MIL-PRF-49465A
AMENDMENT 2
25 January 1994
SUPERSEDING
AMENDMENT 1
10 OCTOBER 1991

PERFORMANCE SPECIFICATION

RESISTORS, FIXED, METAL ELEMENT (POWER TYPE)
(VERY LOW RESISTANCE VALUES),
GENERAL SPECIFICATION FOR

This amendment forms a part of MIL-R-49465A, dated 20 February 1990, and is approved for use by all Departments and Agencies of the Department of Defense.

FIGURE 1. Derating curve for high ambient temperatures. "

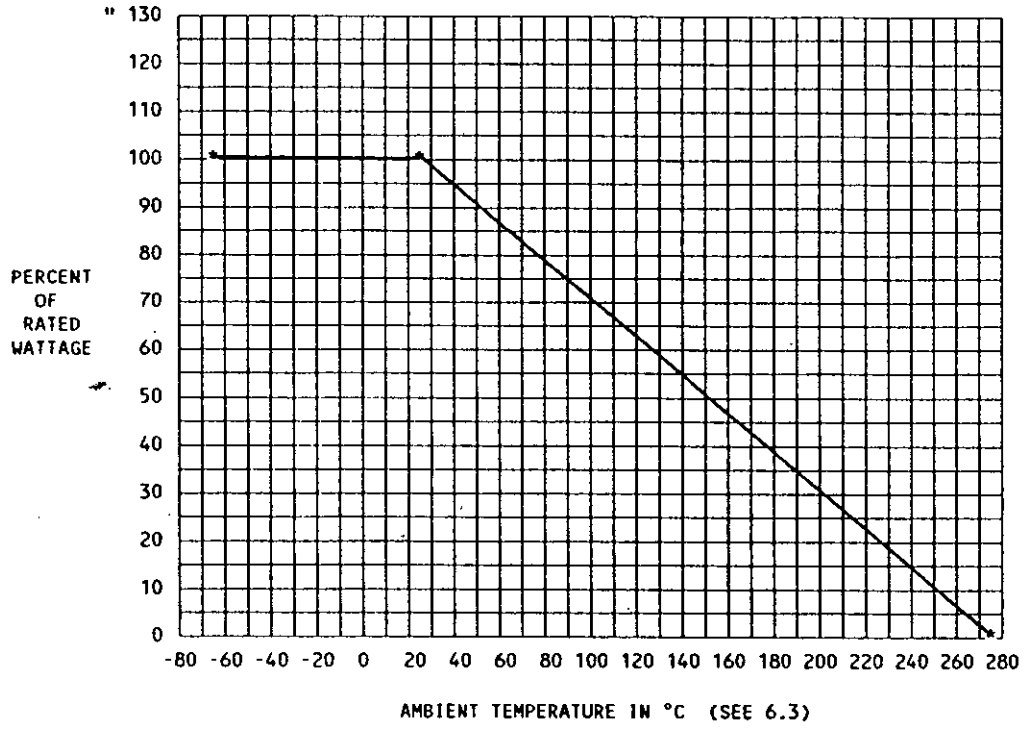
* FIGURE 1, delete and substitute:
